Access Compliance Report Public Rights-of-Way (Curb Ramps)

Intersection ID: 7951 Main Street: BEATTIES FORD RD **Cross Street: N/A** Location: Ε ADA ID: 3183131DB41C Ramp Type: PerpDiag Initial Pass/Fail: Fail **Overall Compliance: No Severity Score:** 8.75

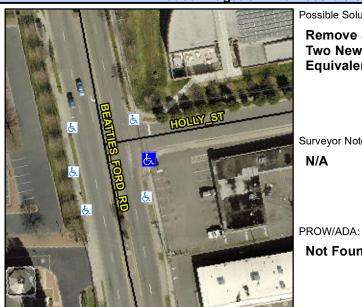
Not Found, R304.5.1

Fleid Measurements/Component Compnance						
	Compl	Compliance Description		Compliance Description		Data
	N/A	Ramp Length (in)	88.5	Yes	Ramp Slope (%)	6.6
	No	Ramp Width (in)	44.0	Yes	Ramp XSlope (%)	0.3
	N/A	Flare Type LT	N/A	N/A	Flare Type RT	N/A
	N/A	Flare Slope LT (%)	N/A	N/A	Flare Slope RT (%)	N/A
	N/A	Flare Traversable LT?	N/A	N/A	Flare Traversable RT?	N/A
	N/A	Landing Length (in)	N/A	N/A	DWS Provided?	N/A
	N/A	Landing Width (in)	N/A	N/A	DWS Contrast?	N/A
	N/A	Landing Slope (%)	N/A	N/A	DWS Length (in)	N/A
	N/A	Landing X Slope (%)	N/A	N/A	DWS Full Width?	N/A
	N/A	Landing Curb? (Y/N)	N/A	N/A	DWS Offset (in)	N/A
	N/A	Shared Landing?	N/A			
	N/A	Gutter Ponding?	N/A	N/A	Gutter Slope (%)	N/A
	N/A	Gutter Lip Ht (in)	N/A	N/A	Gutter X Slope (%)	N/A
	N/A	Painted X Walk1?	No	N/A	Painted X Walk2?	No
		X Walk 1 Direction	To N		X Walk 2 Direction	To W
	N/A	X Walk 1 Width (in)	N/A	N/A	X Walk 2 Width (in)	N/A
		X Walk 1 Slope (%)	1.7		X Walk 2 Slope (%)	2.1

Possible Solutions: Remove & Replace Curb Ramp With Two New Directional Ramps or Equivalent. Surveyor Notes:
